Office Action Summary	Application No. 10/540,661	Applicant(s) NEIGHBOURS, GREGORY JOHN	
	Examiner Adriana Figueroa	Art Unit 3633

DETAILED ACTION

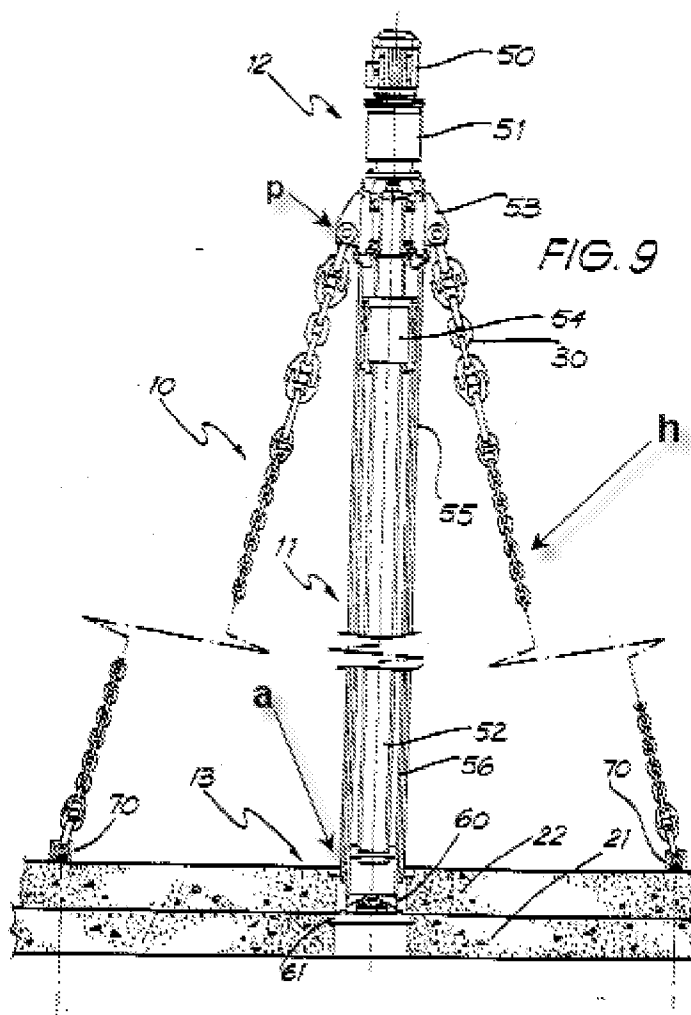
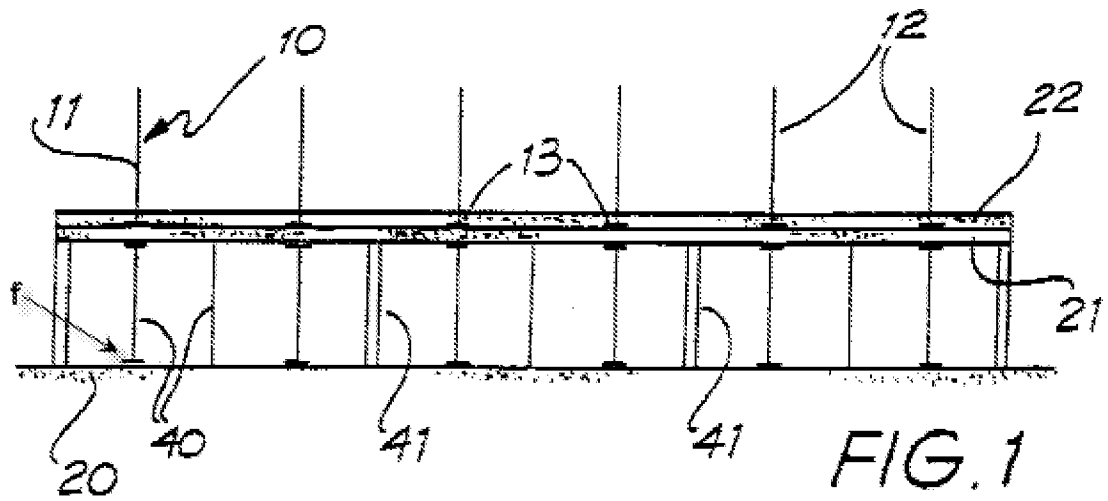
Regarding claim 25, Neighbours discloses a jack (10) for lifting a concrete slab (22) , the jack including: at least one shaft (11) and ball screw (52), a drive assembly (12), a hanger assembly (h), a support device(40, 41) wherein the drive assembly drives the ball screw to raise the shaft with respect to the hanger assembly wherein, the support device supports the shaft to prevent toppling and provide stability, (Figure 1, annotated Figure 9);

Regarding claim 26, Neighbours discloses the drive assembly (12) further drives the ball screw (52) to raise the hanger assembly (h) with respect to the shaft (11) such that in use the jack has lifted a slab (22), (annotated Figure 9).

Regarding claim 33, Neighbours discloses each jack (10) having pivoting means (p) such that in use each jack is capable of accommodating displacement of the jack whereby there is a minimum transfer of moment, (annotated Figure 9).

Regarding claim 34, Neighbours discloses a back prop (40) that can be used to support the floor directly below the jack (10) such that at least two floors below each jack, can be used to provide support, (Fig 1-6).

Regarding claim 35, Neighbours discloses the back prop (40) is provided with a foot member (f), and is capable of redistribute any prop loading through the slab in the floor below the jack, (annotated Fig 1). Neighbours does not disclose the foot member being removable. However, it would have been obvious to one having ordinary skill in the art at the time the invention was made to make the foot member removable since it has been held that constructing a formerly integral structure in various elements involves only routine skill in the art. In re Dulberg, 289 F.2d 522, 523, 129 USPQ 348, 349 (CCPA 1961).
